Project	IEEE 802.16 Broadband Wireless Access Working Group < http://ieee802.org/16 >	
Title	Unsolicited RNG-RSP in Non-transparent RS System under Distributed Scheduling	
Date	2006-03-x5	
Submitted		
Source(s)	<p>Kanchei (Ken) Loa, Yi-Hsueh Tsai, Chih-Chiang Hsieh, Yung-Ting Lee, Hua-Chiang Yin, Shiann-Tsong Sheu, Frank C.D. Tsai, Youn-Tai Lee, Heng-Iang Hsu Institute for Information Industry 8F., No. 218, Sec. 2, Dunhua S. Rd., Taipei City, Taiwan.</p>	<p>Voice: +886-2-2739-9616 loa@iii.org.tw</p>
	<p>Hang Zhang, Peiyong Zhu, Mo-Han Fong, Wen Tong, David Steer, Gamini Senarath, Derek Yu, Mark Naden, G.Q. Wang Nortel 3500 Carling Avenue Ottawa, Ontario K2H 8E9</p>	<p>Voice: +1 613 7631315 WenTong@nortel.com pyzhu@nortel.com</p>
	[add co-authors here]	
Re:	IEEE 802.16j-07/007r2: "Call for Technical Comments and Contributions regarding IEEE Project 802.16j"	
Abstract	This contribution proposes procedures for unsolicited RNG-RSP in non-transparent RS system under Distributed Scheduling

Unsolicited RNG-RSP in Non-transparent RS System under Distributed Scheduling

6.3.10.3.4.4.2 Non-transparent RS with Distributed Scheduling

Table vvv: Unsolicited RNG-RSP triggered by upstream traffic in non-transparent RS system under distributed scheduling

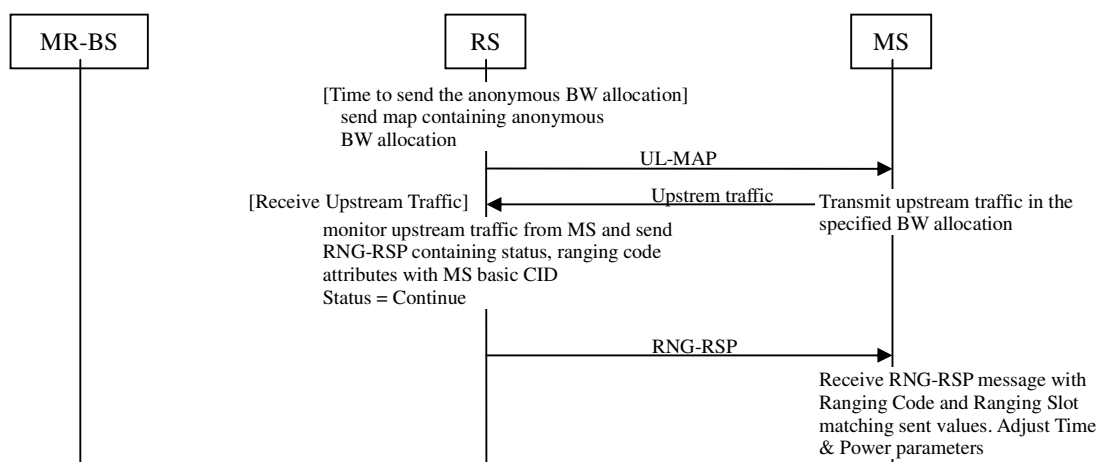
When the offsets of frequency, power, and timing for any data transmission from the MS are beyond the tolerance defined in this specification, RS may send an unsolicited RNG-RSP message to the MS.

The message sequence charts (Table 364, Table vvv) and flow charts (Figure www) define the unsolicited RNG-RSP process that shall be followed by compliant RSs and MR-BSs.

Table yyy: Unsolicited RNG-RSP triggered by BR ranging code in non-transparent RS system under distributed scheduling

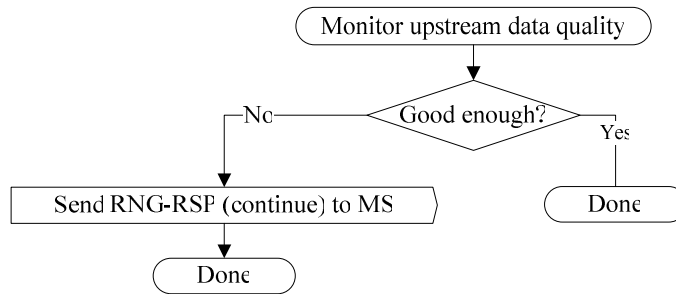
The RS should send an unsolicited RNG-RSP as a response to a CDMA-based bandwidth-request from MS, which results in continue status.

When RS receives the BR CDMA ranging code resulting in continue status, RS shall locally send RNG-RSP to MS on the access link.

The message sequence charts (Table 364, Table yyy) and flow charts (Figure zzz) define the unsolicited RNG-RSP process that shall be followed by compliant RSs and MR-BSs.
